United States Patent and Trademark Office

APPLICATION NO.	FILING DATE	FIRST NAMED INVENTOR	ATTORNEY DOCKET NO.	CONFIRMATION NO.
10/582,198	06/09/2006	Yang Shen	0002860USU/4137	3977
27623 7590 12/12/2007 OHLANDT, GREELEY, RUGGIERO & PERLE, LLP ONE LANDMARK SQUARE, 10TH FLOOR			EXAMINER	
			GLUCHOWSKI, KRISTINA R	
STAMFORD, (STAMFORD, CT 06901		ART UNIT	PAPER NUMBER
			3673	
•			MAIL DATE	DELIVERY MODE
			12/12/2007	PAPER

DETAILED ACTION

Response to Amendment

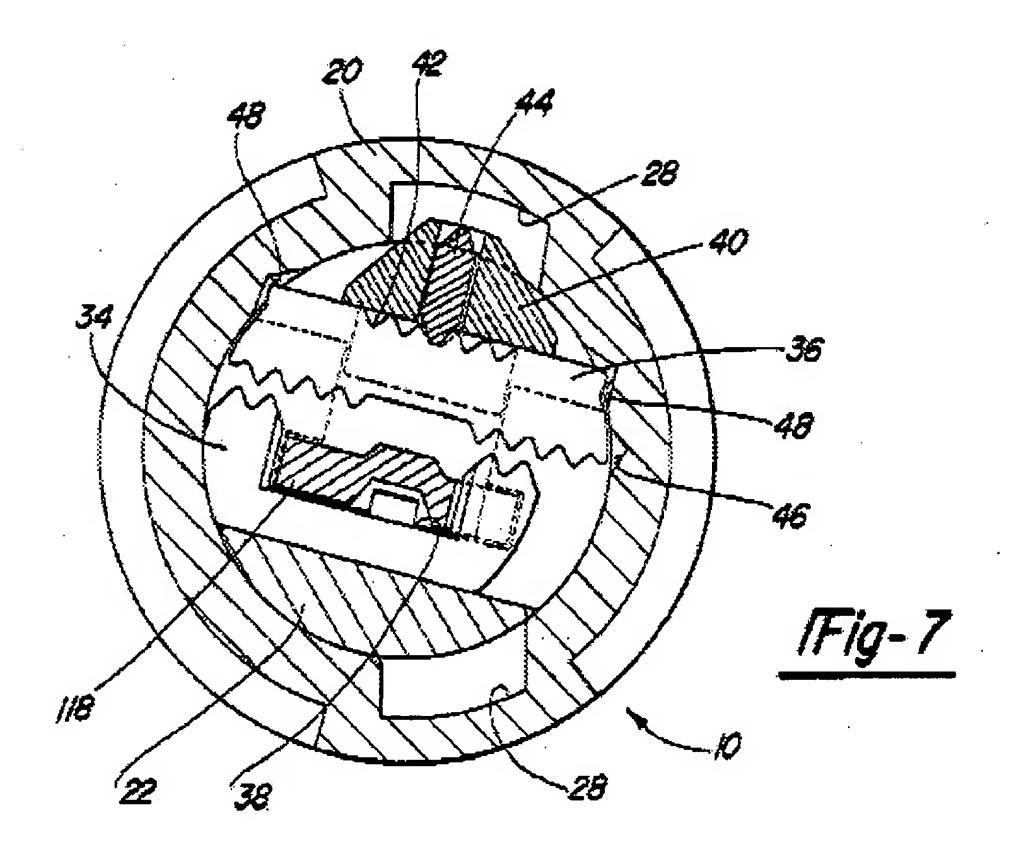
Regarding claims 7 and 22, Boag shows a key-changeable lock, including a lock 4. housing (20), a lock cylinder (10) able to rotate within the lock housing about a rotational axis, said lock cylinder including at least, a locking block (44) slidably mounted on a periphery of said locking cylinder, to be located in one of two working positions, in a first working position said locking block extends from the lock cylinder to engage the lock housing preventing rotation of the lock cylinder (figure 7) relative the lock housing and in a second working position, the locking block at least partially retracts into the lock cylinder (figure 6) to allow said relative rotation, at least one blocking piece (40) to move to selectively allow or block retraction of said locking block into said lock cylinder, at least one slide (36) to move in said lock cylinder, transverse to said rotational axis, said slide having an engaged and disengaged position with said at least one blocking piece, said at least one blocking piece moving in a fixed relationship with said at least one slide when in said engaged position, and in a variable relationship when in said disengaged position, a sliding block (34) adapted to move said at least one slide between said engaged and disengaged positions, and a locking hole (26) provided on or in the lock cylinder and into which a key (118 or 218) is inserted, characterized in that insertion of a first key into a locking hole, moves said at least one slide and in turn said at least one blocking piece, in said engaged position therewith, to allow retraction of said locking block and thus rotation of said lock cylinder, retraction of said at least one blocking piece into said lock cylinder, prevents said locking block from moving, and moves said at least one slide to said disengaged position via said sliding block, and removal of said first key and insertion of a second key moves said at least one slide and

varies the relation of said at least one slide and said blocking piece, due to said disengaged position, such that said second key now locks and unlocks said key changeable lock or subassembly therefore (see abstract for description of first and second key).

- Regarding claim 8, the first key is removed and said second key is inserted with said cylinder in a partially rotated condition (see abstract and figures 6-7).

- Regarding claim 9, the engagement of said slide with said blocking piece is via a toothed piece (see figures 6 and 7 for illustration of teeth) on said slide engaging a toothed piece (see figures 6 and 7 for illustration of teeth) on said blocking piece, there being more teeth on one than the other to allow said variable relationship.

- 7. Regarding claim 10, said blocking piece has a block groove (slot in top of 40 for insertion of 44) thereon running parallel to said locking block, said blocking piece, either side of said block groove, blocking retraction of said locking block, other than when said blocking piece is moved to allow said locking block to retract into said blocking groove.

- Regarding claim 11, said locking block is urged into said block groove, and is held in the block groove, by the profile of said lock housing about said lock cylinder, when said lock is unlocked (see figure 6).

- Regarding claims 21 and 27, a locking groove (28) is provided on the lock housing; when the locking block is located at the first working position, the locking block is received in the locking groove; and each side face of the locking groove is provided with a guiding slant (see figure 7 for slanted edges). See the Boag device below.

FIG. 18

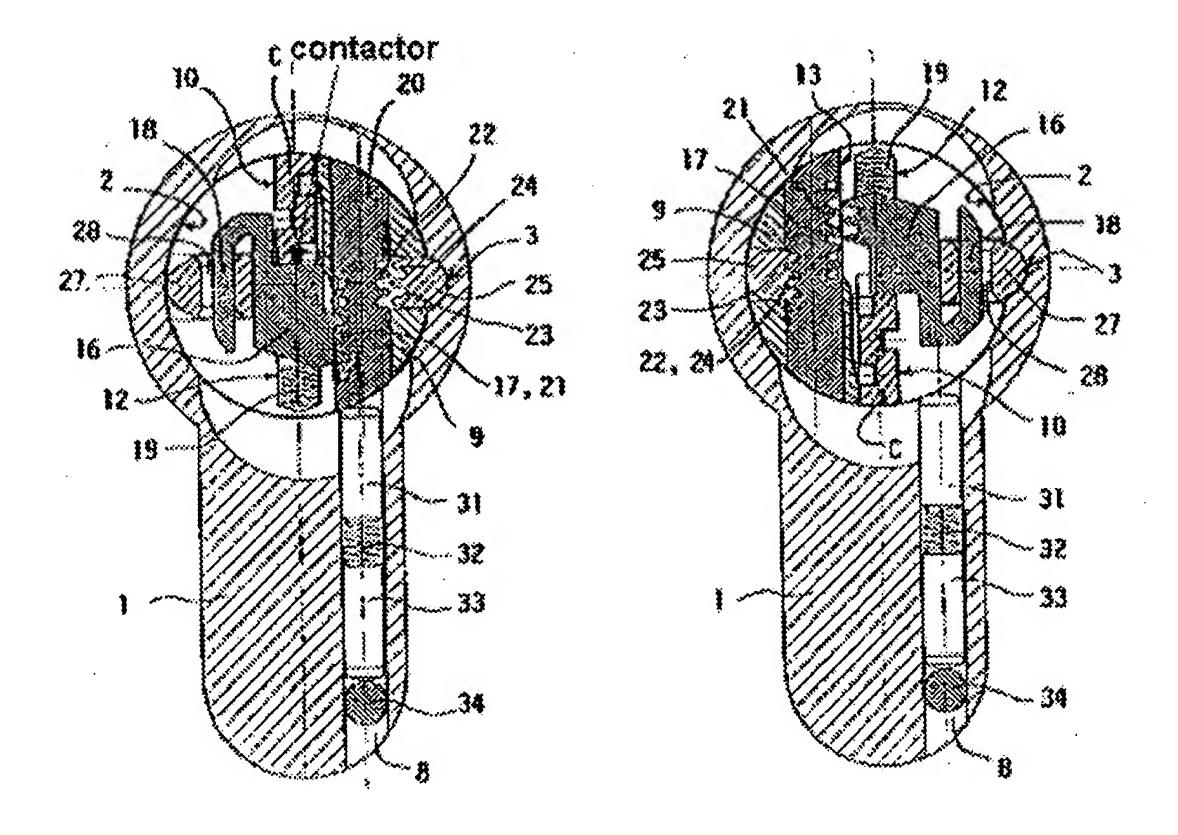
- 3. Claims 13-15 and 23-24 are rejected under 35 U.S.C. 103(a) as being unpatentable over Boag as applied to claim 7 above in view of Loreti (US 6119495). Boag shows applicant's basic inventive concept but fails to show spring bias components. Loreti shows that it is well known in the key cylinder art to include springs. Loreti shows a key-changeable lock, comprising a lock cylinder (9), a sliding block (18), toothed slides (17), and a blocking piece (20).

- 4. Regarding claims 13 and 23, Loreti shows springs (19) are provided between the sliding block and the shell.
- 5. Regarding claims 14-15 and 24, Loreti shows a compression spring (26) is provided between the toothed slide and the sliding block.

- 6. Regarding claims 13-15 and 23-24, it would have been obvious to one of ordinary skill in the art to include springs in the cylinder to assure proper engagement and movement of the components within the cylinder. It is very well known in the art to use springs. See the Loreti device below.
